Volvo Chassis - Model VNX - One piece Propeller Shaft (Drive Shaft) Contacts Cross Member

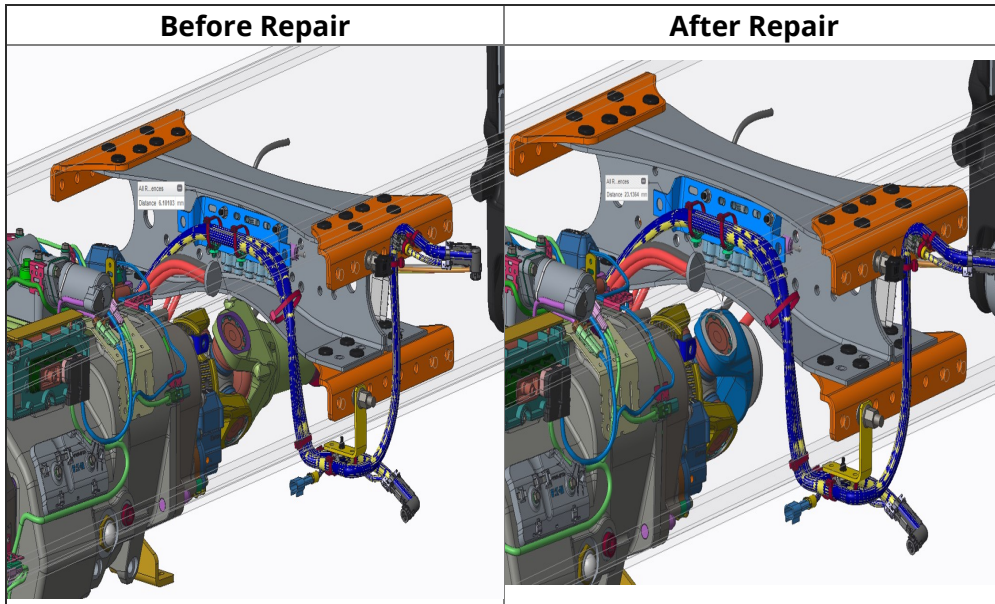
The yoke of the one piece propeller shaft (Drive Shaft) MAY contact the back to back "C" channel cross member under acceleration and/or suspension articulation. The solution would be to flip-flop the propeller shaft end for end. This will give the necessary clearance.
